PLANNING & ZONING AGENDA ITEM #6

SUBJECT: Approval of a Site Plan for Alice Place Retirement Village [255 SE Brick Drive]

COMMENT RESPONSE LETTER

RE: Alice Place Retirement Village – Site Plan

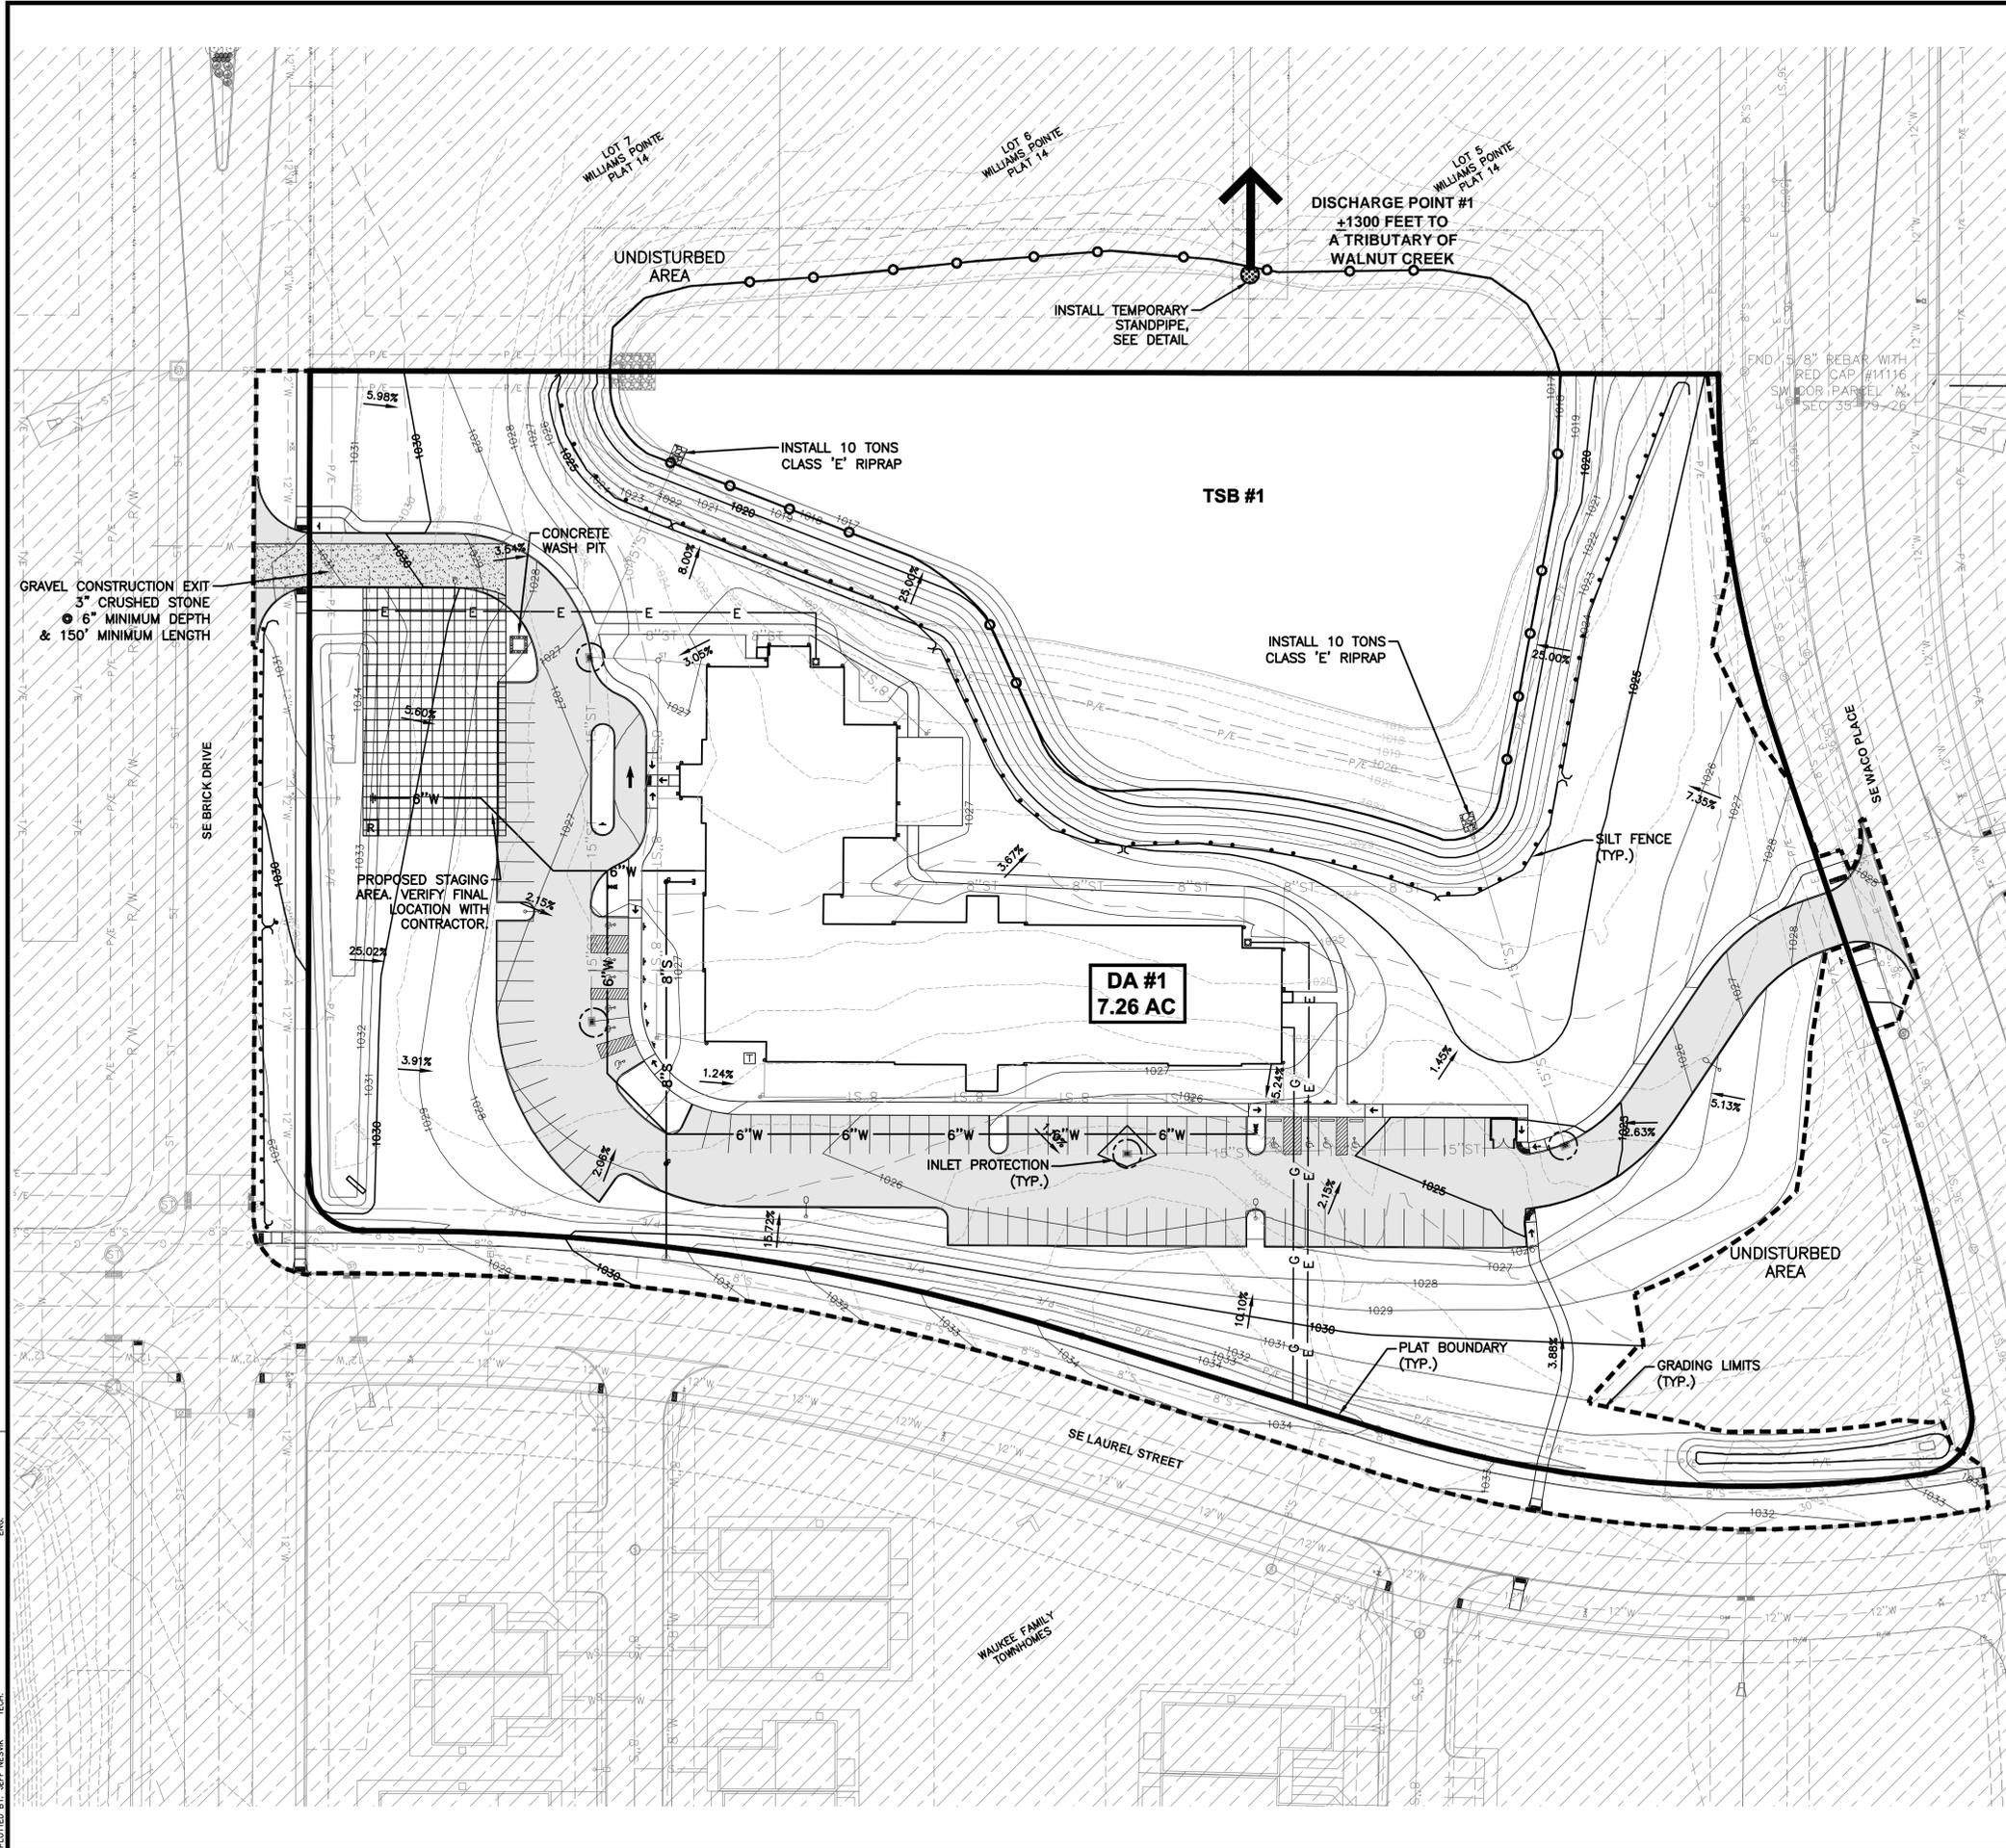
24. **Grading Note #13 should be revised to eliminate the question as to when the installation of said improvements are necessary to identify the need to provide an as-built grading plan to the City of Waukee Engineering Department.**
25. Spot elevations should be provided at all proposed building corners.
26. The 100-year flood limit should be illustrated on the site plan for clarity.

27. ~~The detention pond overflow route should be indicated on the site plan.~~
28. ~~Staff questions if a rock shoulder needs to be installed around the pond edge to prevent erosion. Please address.~~ **Staff questions how the edge of the pond is intended to be stabilized. Please address.**
29. ~~ADA ramps should be provided for all applicable handicapped aisles indicated on the site.~~ **Staff questions if curb stops or bollards should be provided to keep vehicles from encroaching on the sidewalk adjacent to the handi-capped stalls. Please address.**
30. ~~Staff would request that berming be provided in the southeast corner of the site to correspond with the proposed landscaping to provide for a better buffering between the proposed apartment building and single family residential properties off of SE Waco Place. Please address.~~

- a. **The note has been modified.**
28. ~~Staff questions if a rock shoulder needs to be installed around the pond edge to prevent erosion. Please address.~~ Staff questions how the edge of the pond is intended to be stabilized. Please address.

- a. **I will discuss this with the client. The intention is to have a manicured grass edge up to the pond. No riprap is being proposed at this time.**

ALICE PLACE RETIREMENT VILLAGE
EROSION AND SEDIMENT CONTROL PLAN
 WAUKEE, IOWA

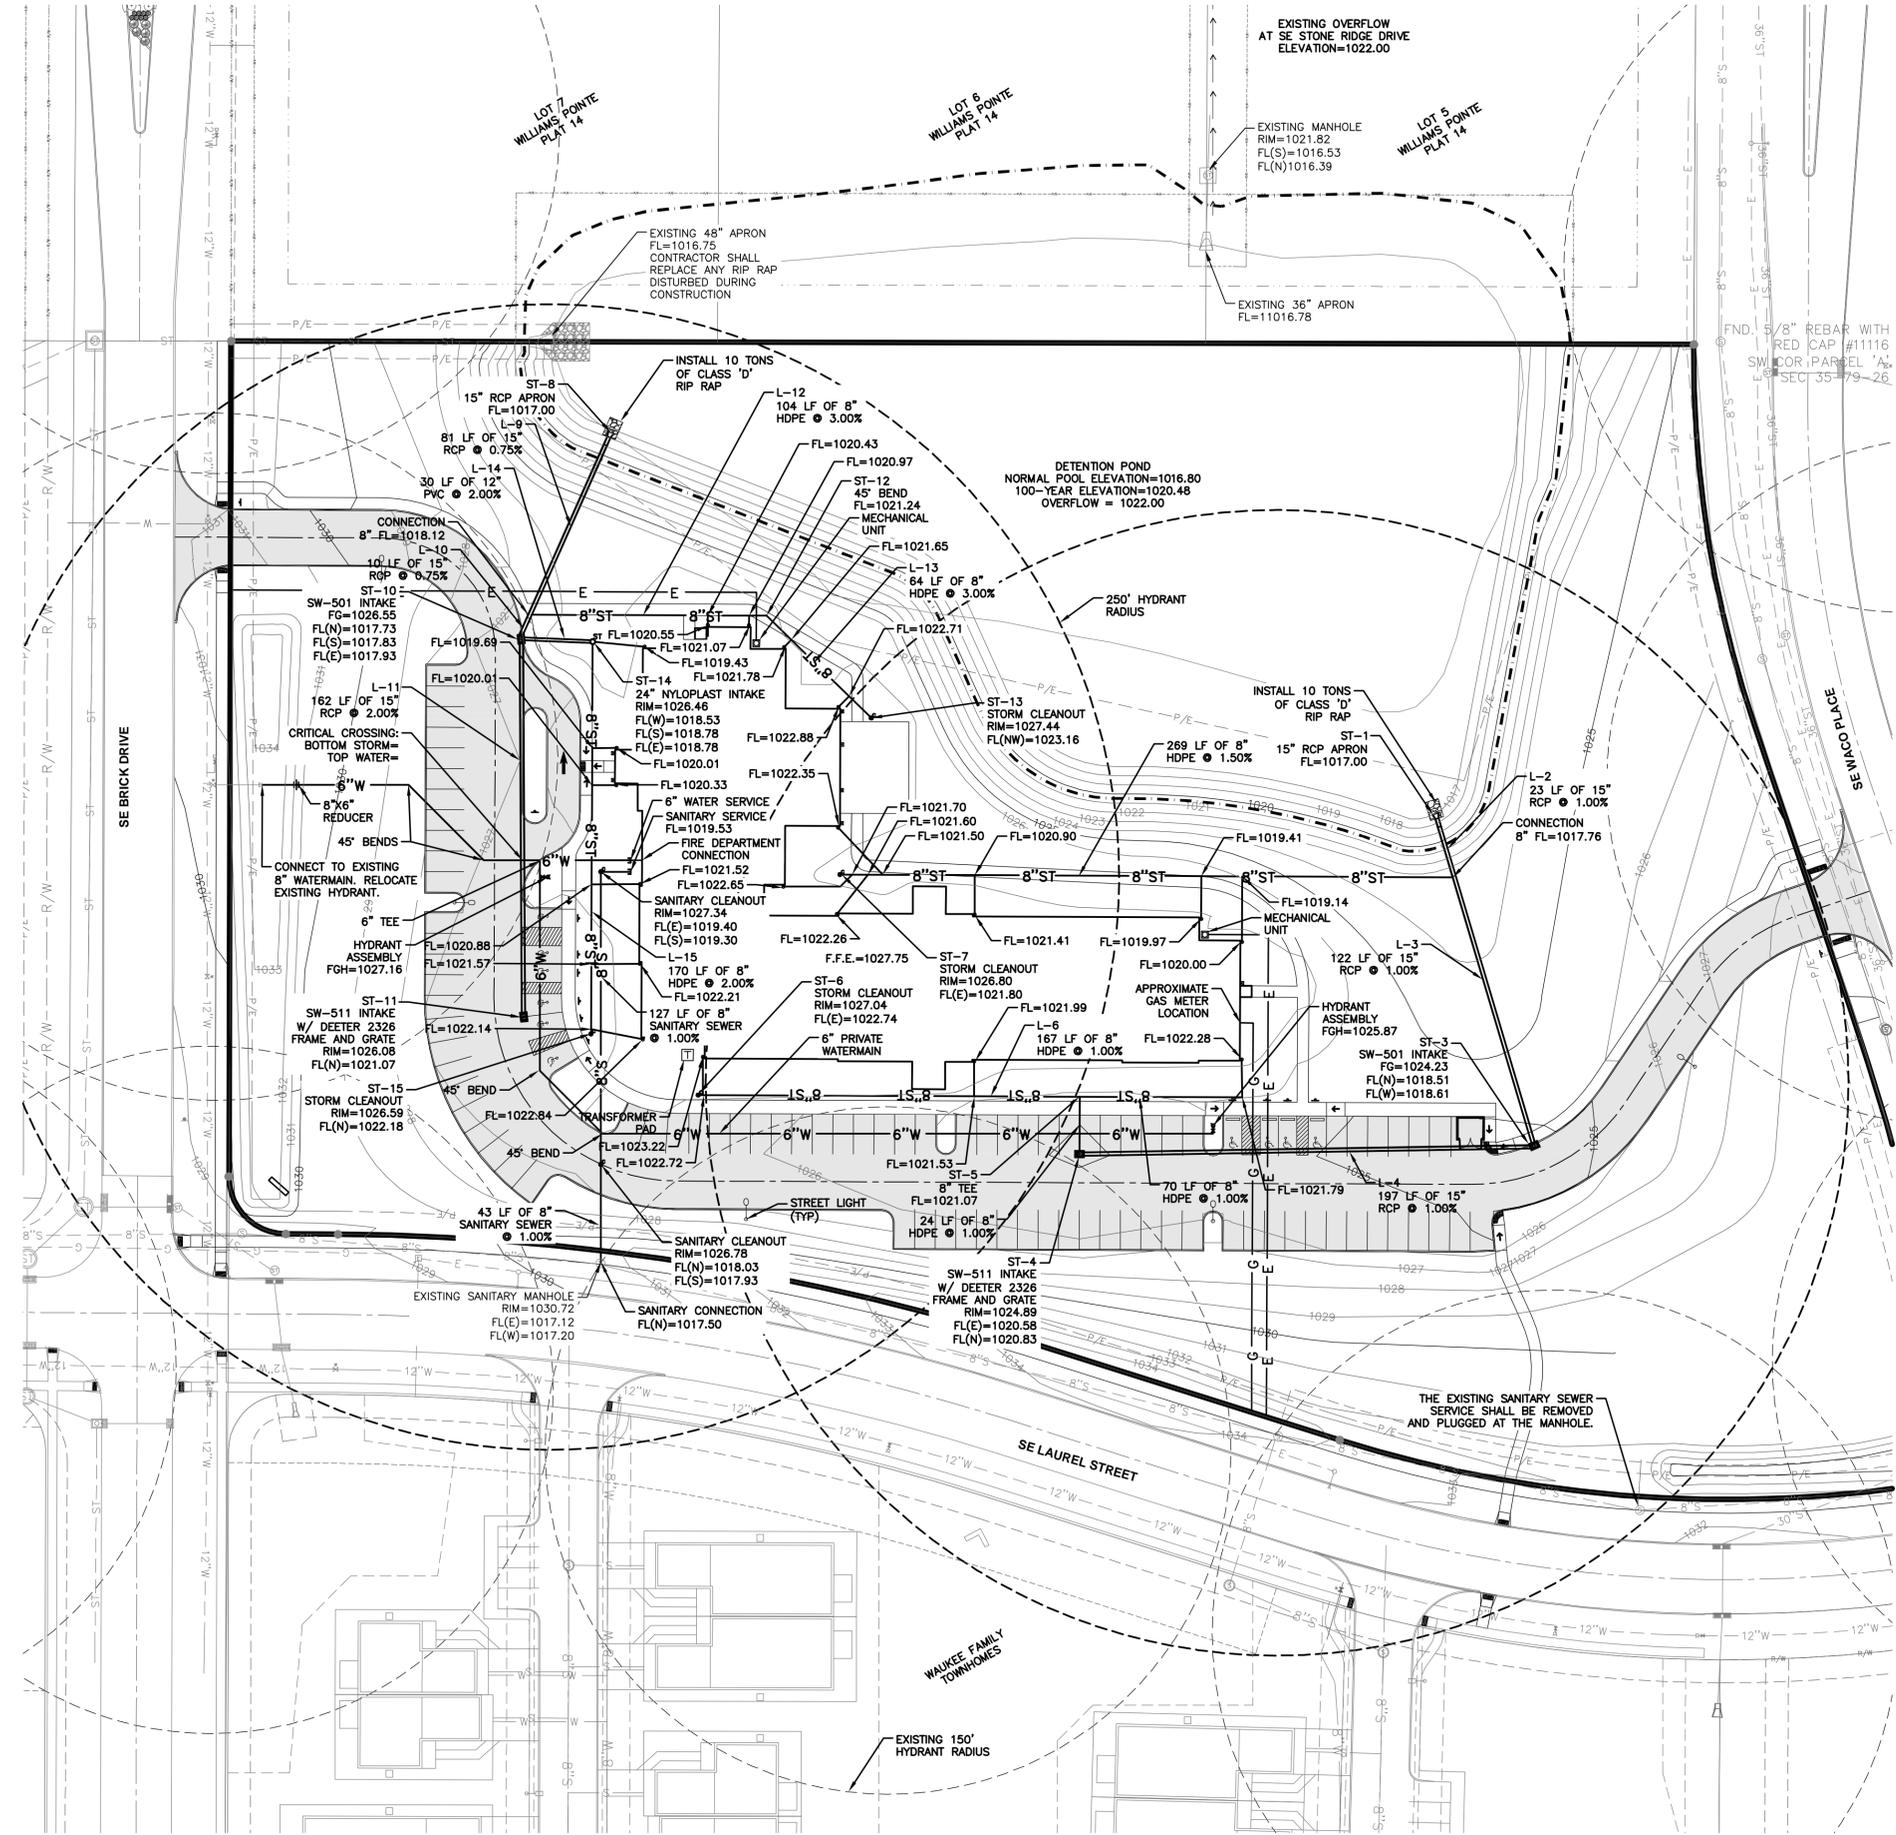
31. **The note related to the construction entrance location should be legible.**
32. **Staff questions if any modification is needed relative to the existing flared end section outlet and the corresponding rip-rap due to the proposed grading work extending near this location. Please address.**

31. The note related to the construction entrance location should be legible.
- a. **This has been modified.**
32. Staff questions if any modification is needed relative to the existing flared end section outlet and the corresponding rip-rap due to the proposed grading work extending near this location. Please address.
- a. **A note has been added to the utility plan to address the rip-rap.**
